ETIHAD STADIUM NORTH STAND EXPANSION **NON-MATERIAL AMENDMENT SUMMARY**

26/07/2024

NSE-POP-ZZ-ZZ-TR-A-008112

Proposed updates to drawing NSE-POP-NS-00-DR-L-000600, showing overall landscape general arrangement.

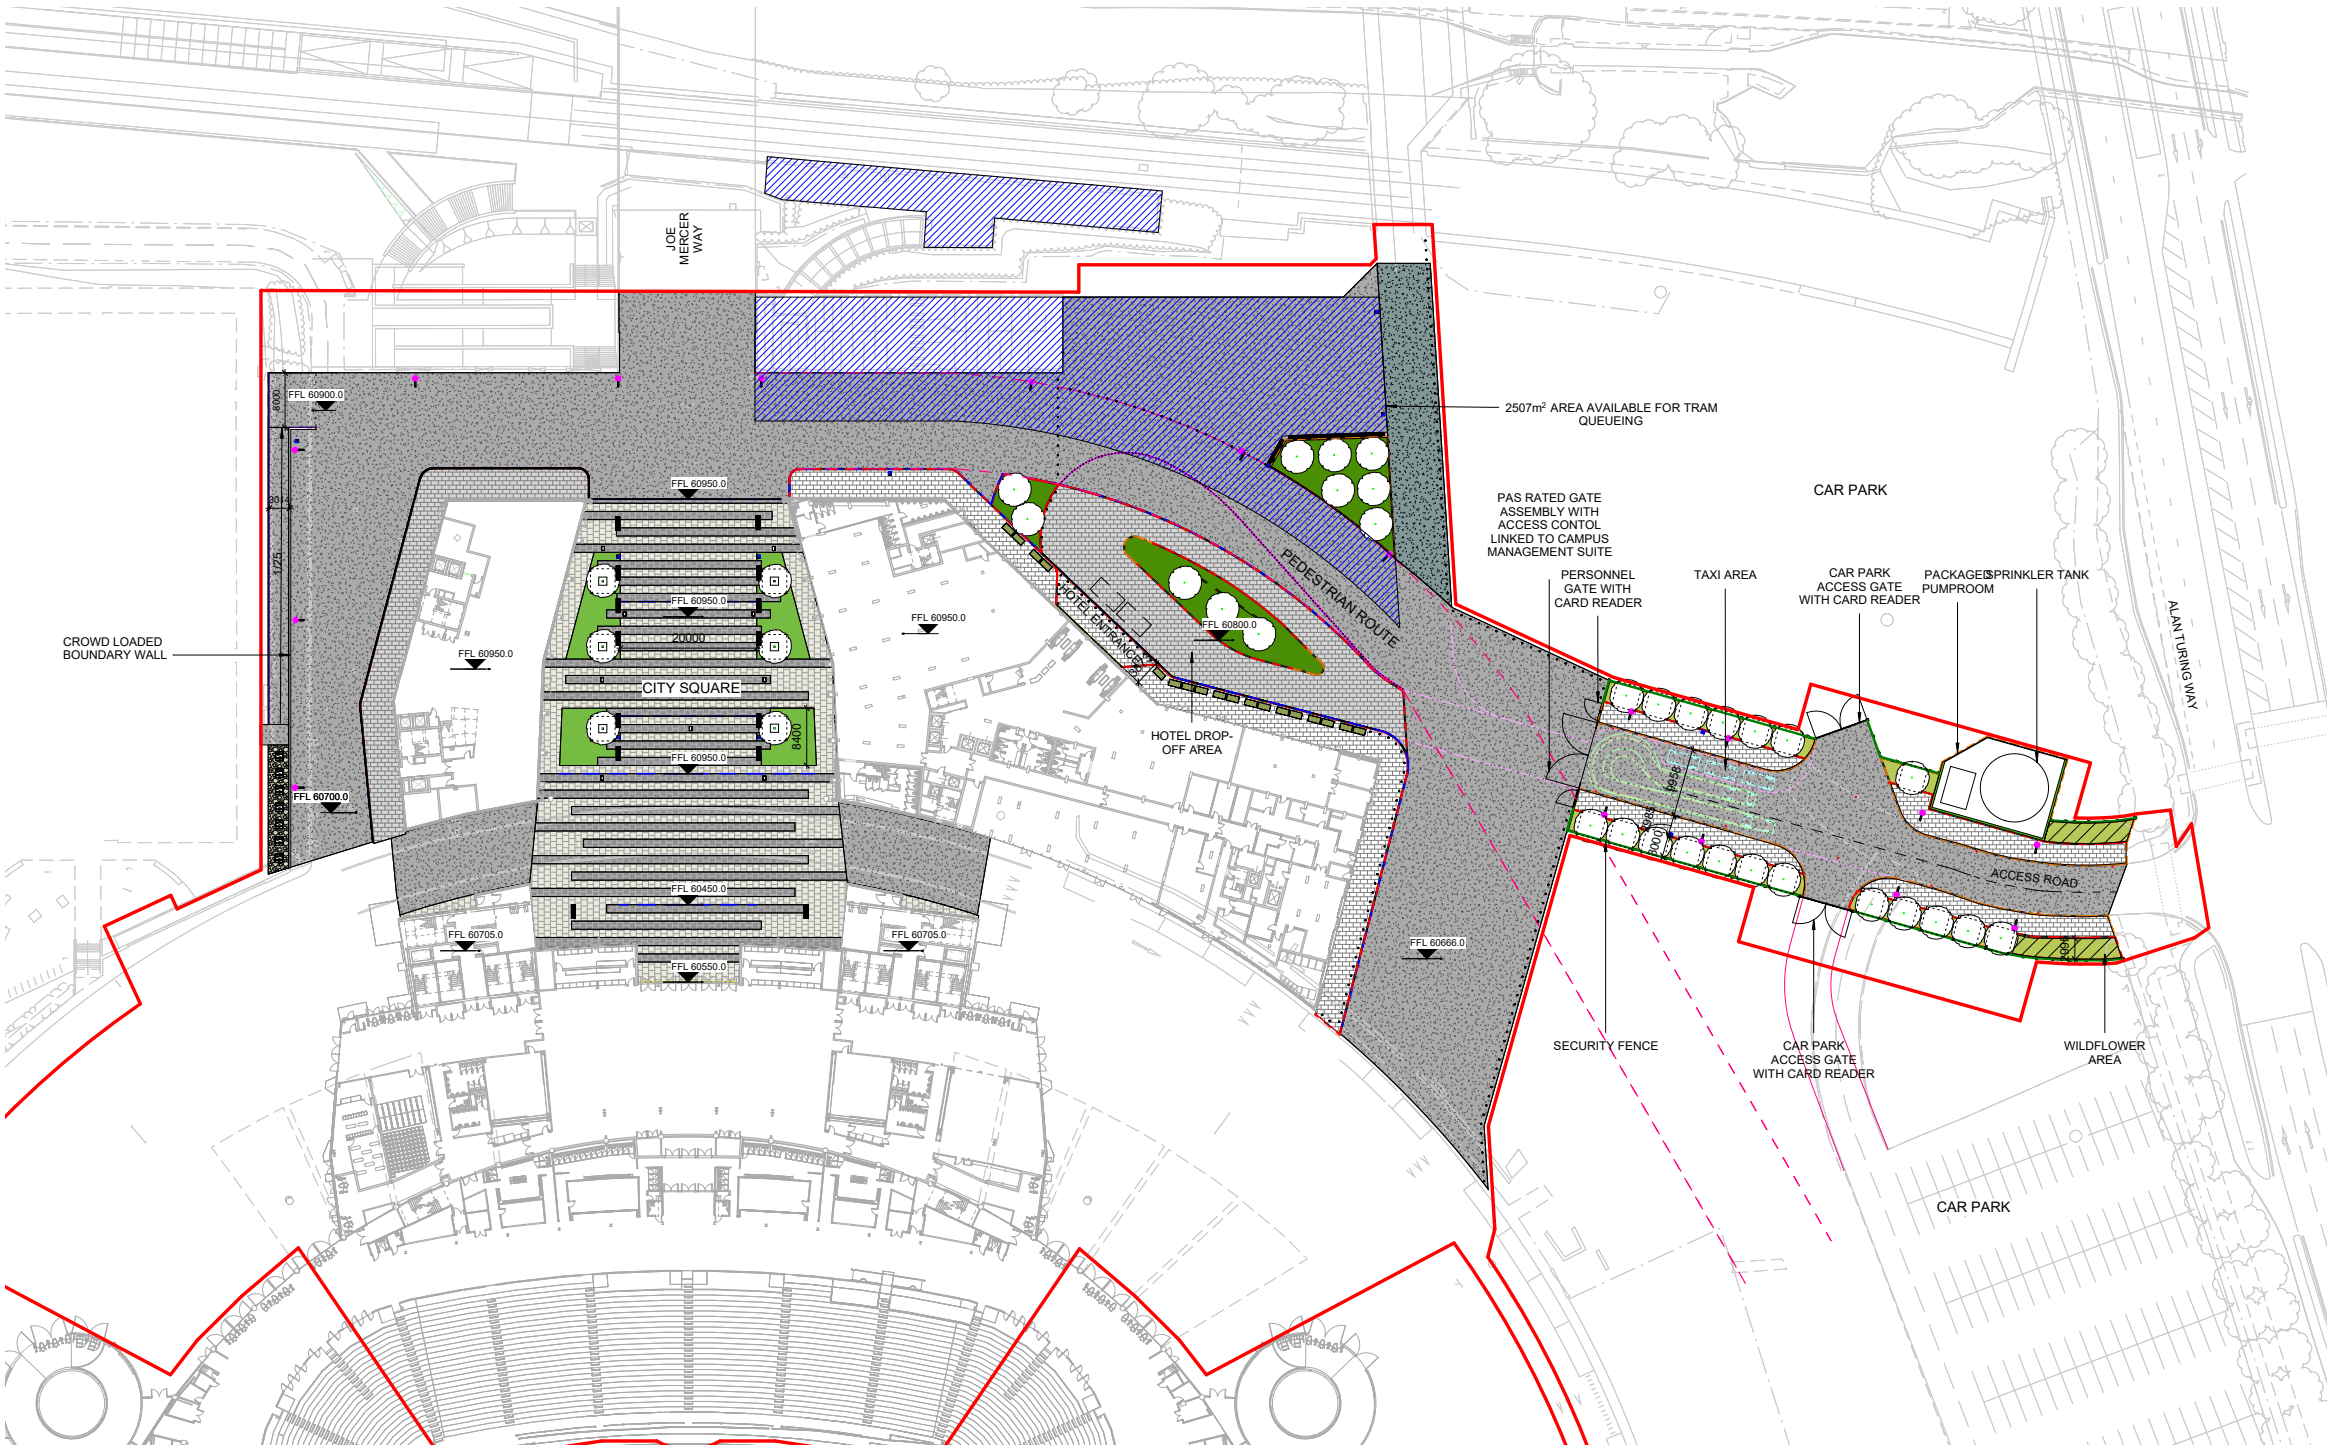
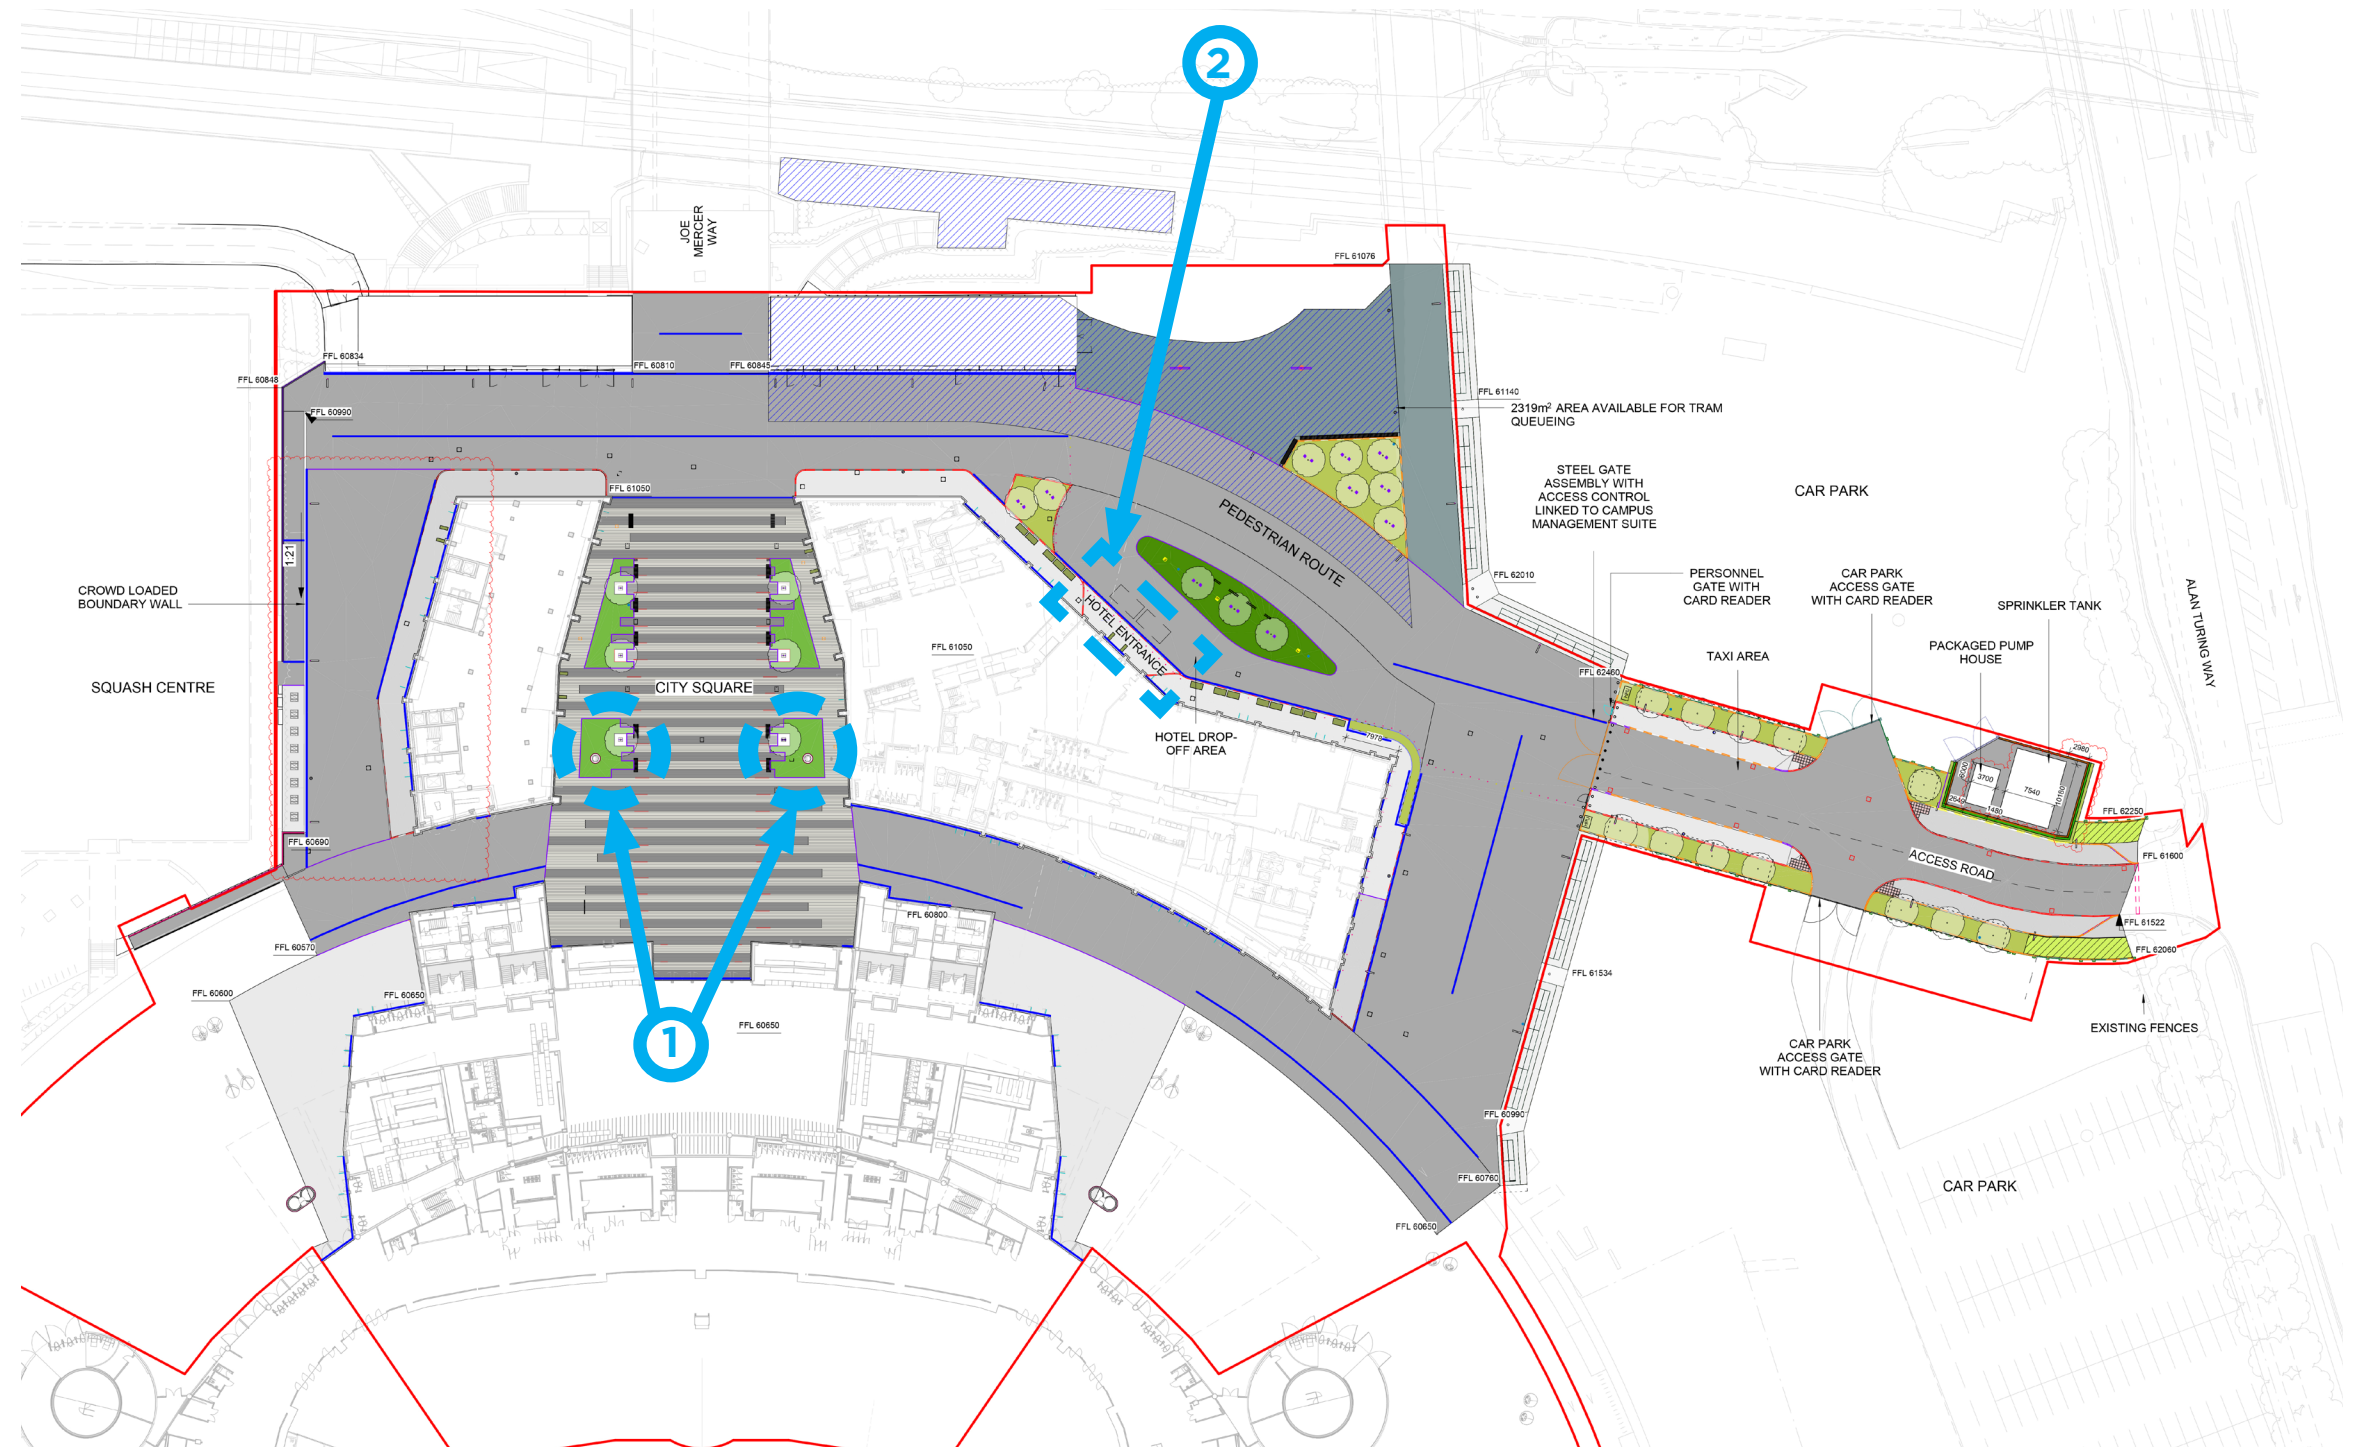
- General drainage updates around the site to coordinate with the civil engineering team.
- Additional clarity provided to either side of the North Stand expansion itself.

Incorporation of feature drainage 'chutes' in City Square that match existing examples elsewhere around the stadium.

Planters around the Hotel entrance have been updated in coordination with other protective measures for pedestrians with outward-swinging egress doors.

Extract from NSE-POP-NS-00-DR-L-000600, showing proposed tank enclosure.

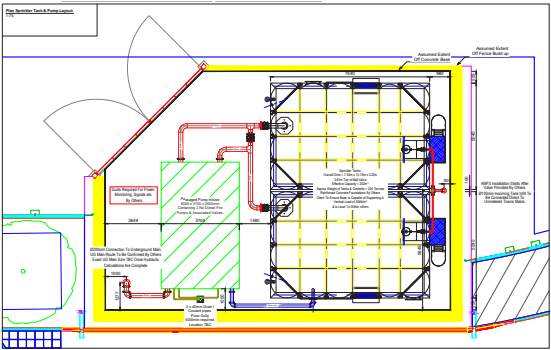
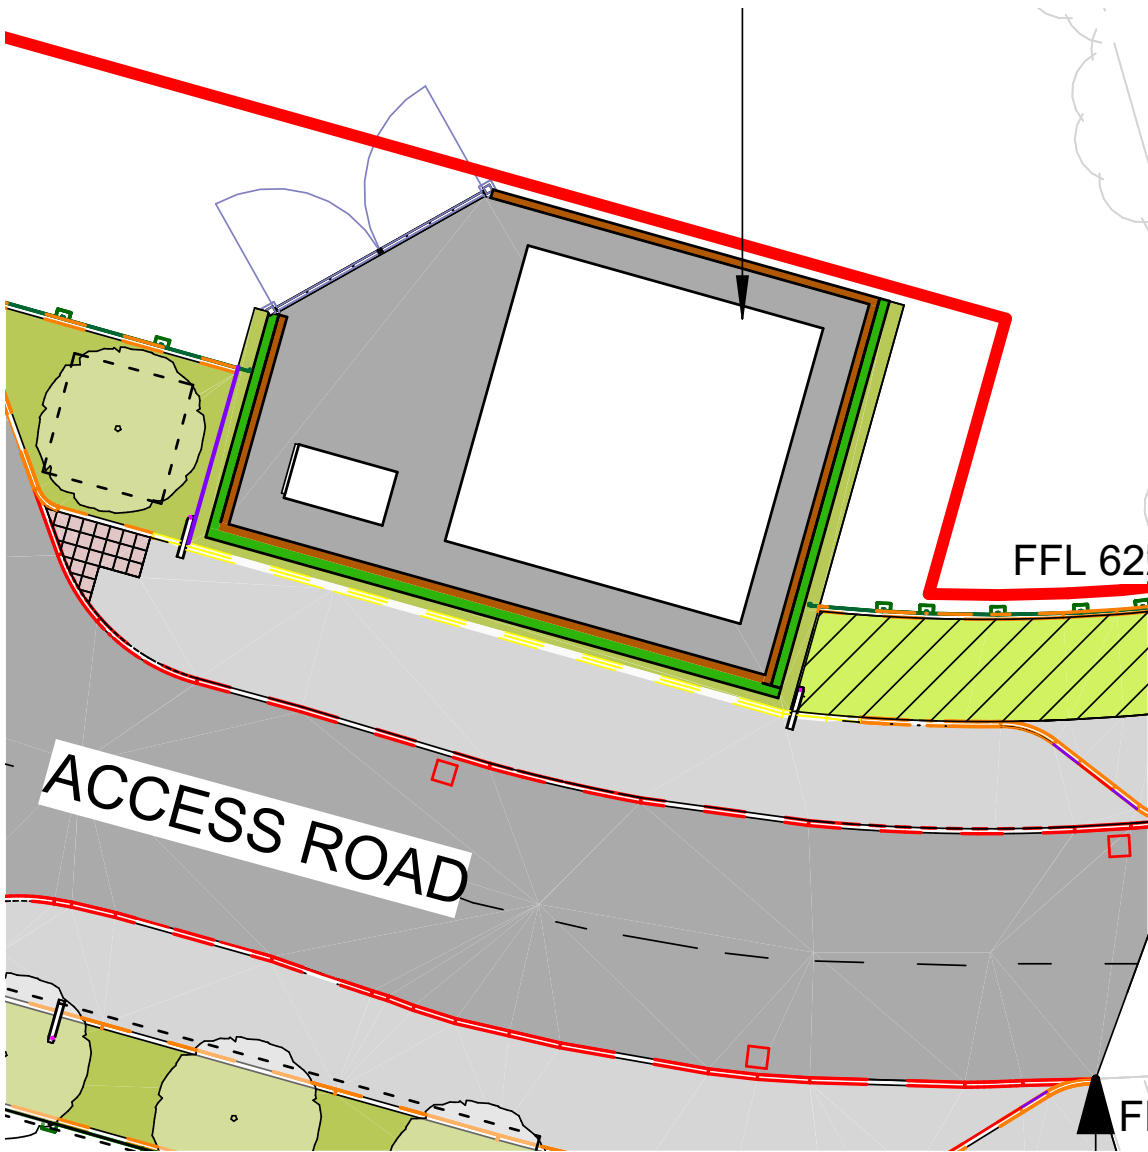
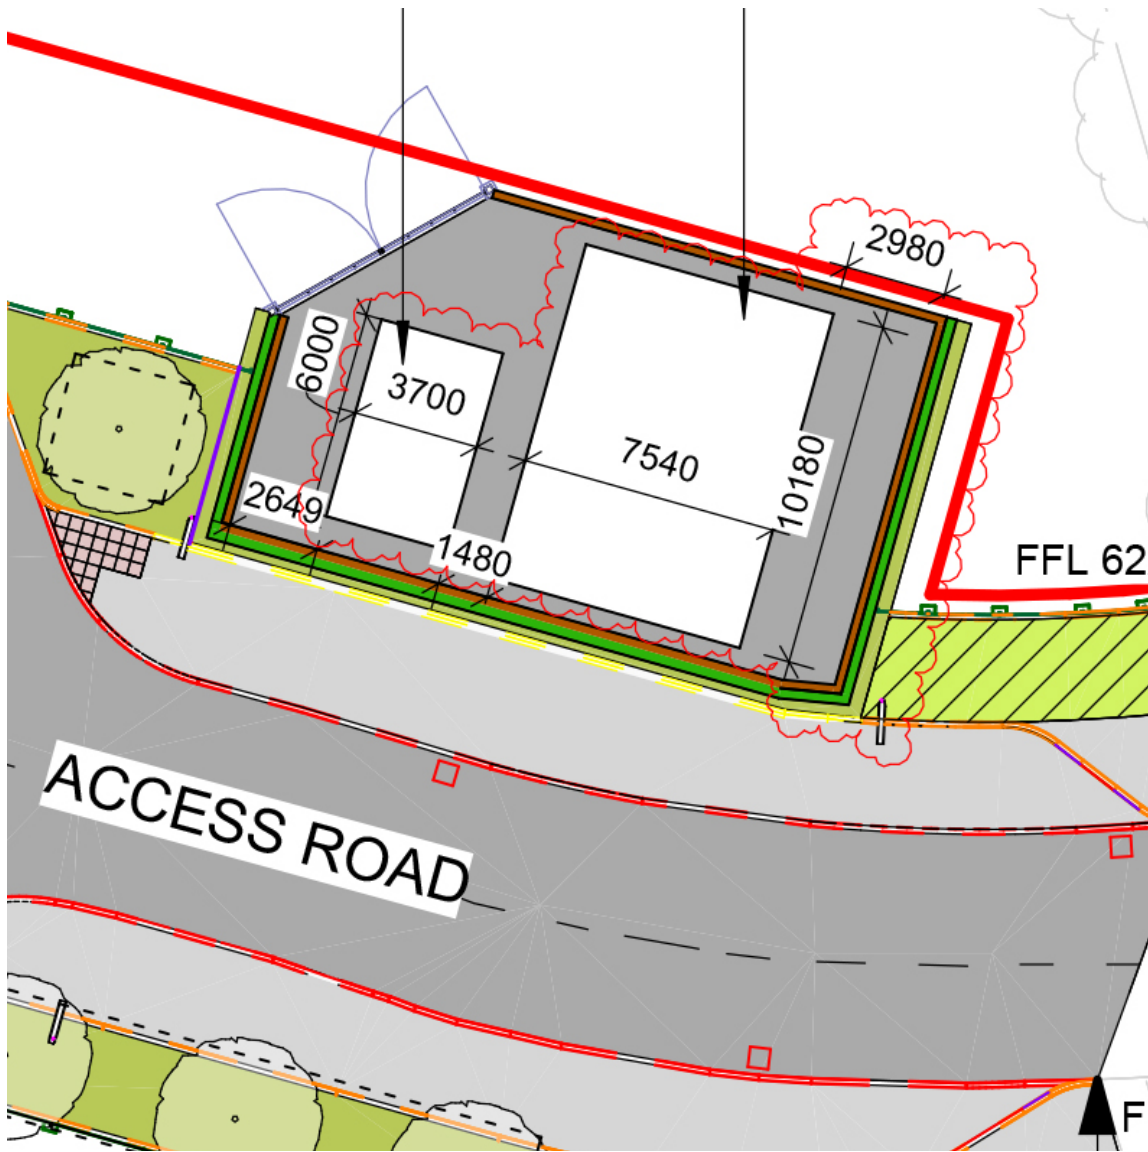
As the design of the sprinkler tank area has progressed with specialist input, it was established that the size of the enclosure would need to increase.

The previous enclosure could house the tank and pump equipment, but would not allow sufficient space for future maintenance.

As a result of the slight expansion, the corner of the enclosure has been splayed to avoid encroaching on to the footpath.

Exploded axonometric view of proposed Commercial Building uses by level.

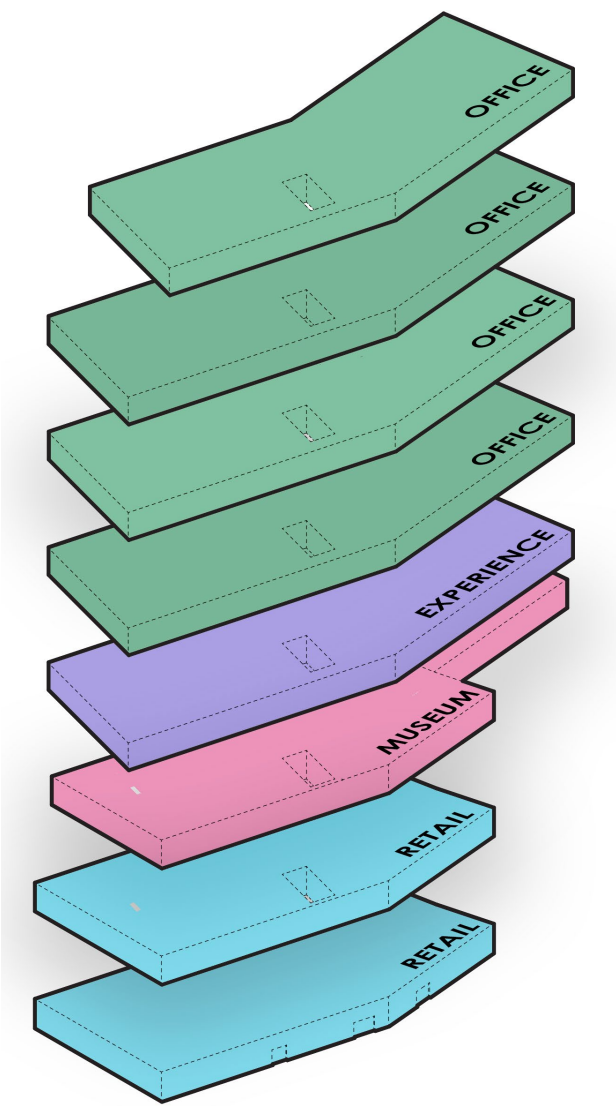
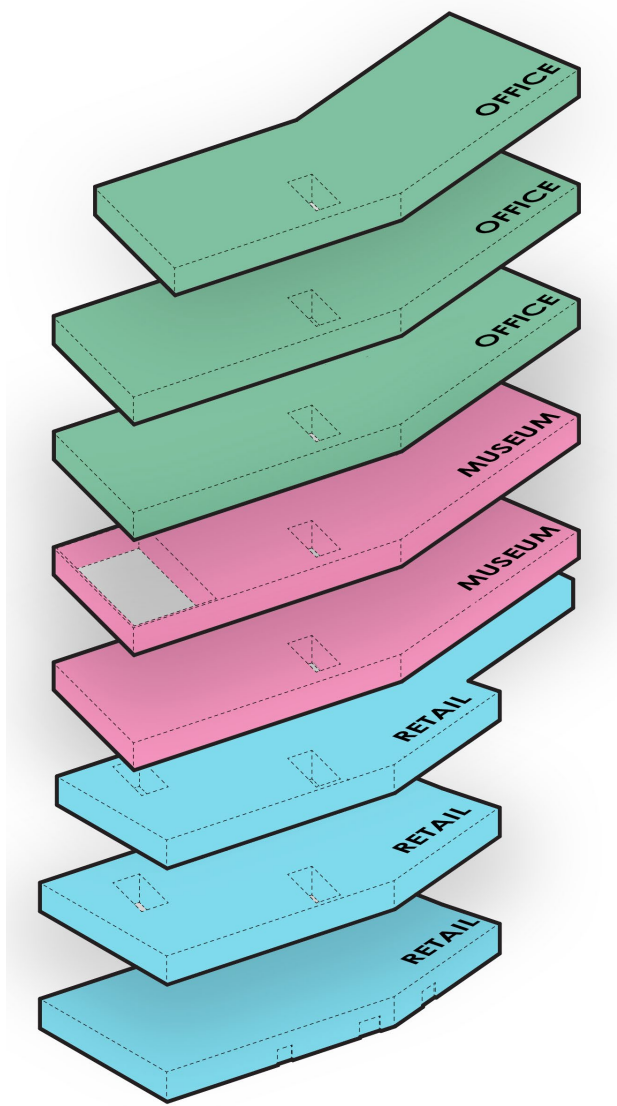
The retail space, originally located on Levels 00 and 01, is proposed to also include Level 02. The Museum would move to Level 03 and expand to include Level 04. Office spaces would remain on Levels 05, 06 and 07.

As part of these amendments, some additional voids within the structure are proposed to better link the spaces and provide some architectural drama to the spaces. These voids connect all three floors of the retail space, and a large double height space sits at the northern end of the Museum.
